#### Agenda item 2

# Proposal for a new UN Regulation on

# Uniform provisions concerning the approval of vehicles with regard to Automated Lane Keeping Systems

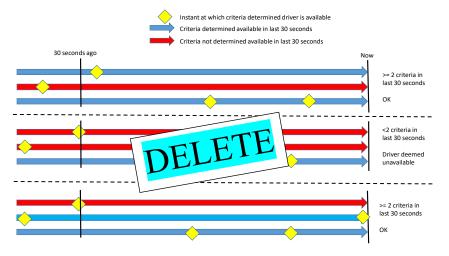
Remark ACSF: Diagram above introduced to delete the diagram below!
